Re: Draft Environment Impact Report for the Waterfront Ballpark District at
Howard Terminal, Oakland. (Project # ER18016)

I am writing on behalf of my client, the Jack London District Rail Safety Working Group (RSWG), to comment on the above-referenced Draft Environmental Impact Report (DEIR). The RSWG is composed of a wide range of residents, home and business owners, employees and other interested parties in the Jack London District (the District). The RSWG is enthusiastically supportive of the Waterfront Ballpark District at Howard Terminal (Project) with its anticipated major uplifting impact to the surrounding area, particularly in the District. However, the RSWG believes that the DEIR is deficient in its treatment of Project-associated transportation impacts, and more specifically, impacts on pedestrian safety from Broadway to Oak Street that are excluded from the proposed rail safety zone from Market Street to Broadway.

Oakland Waterfront Balpark District Project
Figure 4.15-4
 Pedestrian Influence Area

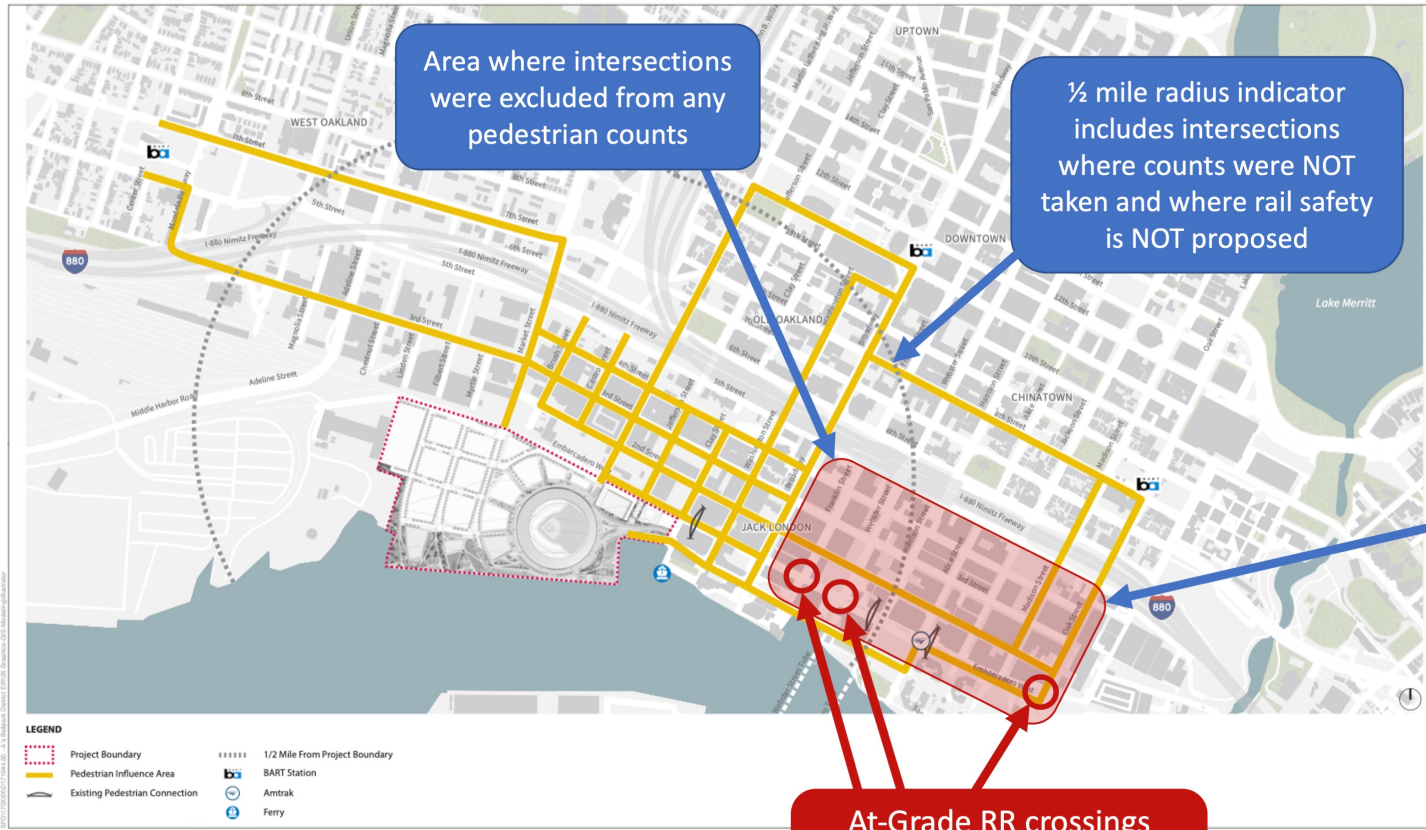
To what extent were more “direct” routes presumed to be favored, and by how much? How was the “quality of the pedestrian experience” evaluated? How were these two factors balanced? Would a slightly longer route, but with a “better” pedestrian experience be favored or disfavored, and by how much? For example, for pedestrians arriving at Lake Merritt BART, or returning from the Project to that same BART station, the walking route along Oak Street through the District would pass dozens of restaurants, bars and entertainment venues between Lake Merritt BART and the Project, especially along Water Street (see attached Appendix A). Further, Figure 4.15-46 only identifies pedestrian routes for arrival at the Project. What about trips returning from the project? The two would not necessarily be the same. Does the trip assignment take into account the expected desire of patrons at Project events for after-game food, drinks, or other entertainment? Shouldn't that be taken into account in making trip assignments? The District features more than 10 breweries, taprooms, wineries and tasting rooms that are part of the popular “Oakland Ale Trail.” These destinations can be expected to try to capitalize on game day activity by staging, and advertising, post-game promotions. Those promotions will undoubtedly make the route through the District at least as desirable as the route along 8th street indicated in Figure 4.15-4, which features fewer such venues.

The DEIR (p. 4.15-7) identifies that “the study area was expanded beyond the one-half-mile radius along these corridors because pedestrians are expected to use them to walk between the Project site and transit/downtown.” However, as highlighted in the figures shown in Appendix A (the ½ mile radius indicated by the dashed circle), areas well within the ½ mile radius, and just beyond, were not included in the pedestrian counts provided in the DEIR and its appendices. Despite not including any pedestrian counting analysis in the area highlighted in Appendix A, the DEIR nevertheless includes estimates of pedestrian traffic through that same area, without any explanation of how those estimates were derived. Its conclusions, unsupported by evidence in the record, must be considered arbitrary and capricious. In fact, the RSWG believes, based on many years of experience with pedestrian preferences traveling to and from special events, that the DEIR's estimates of this pedestrian traffic substantially underestimate the pedestrian traffic likely to opt for a route to/from Lake Merritt BART and nearby parking going through the District. The DEIR does identify certain wayfinding measures intended to direct foot traffic through Chinatown. However, pedestrian attractions along routes through the District can also be expected to take actions to entice pedestrians to travel through the district.¹ Consequently, it should be expected that at least as much of this foot traffic will opt for a route through the District, its waterfront venues and its bars and wineries, as opt to travel by way of Chinatown.

Bars, Restaurants and Entertainment Venues in the highlighted portion of the Jack London district where pedestrian counts were NOT taken and where rail safety mitigation is NOT proposed
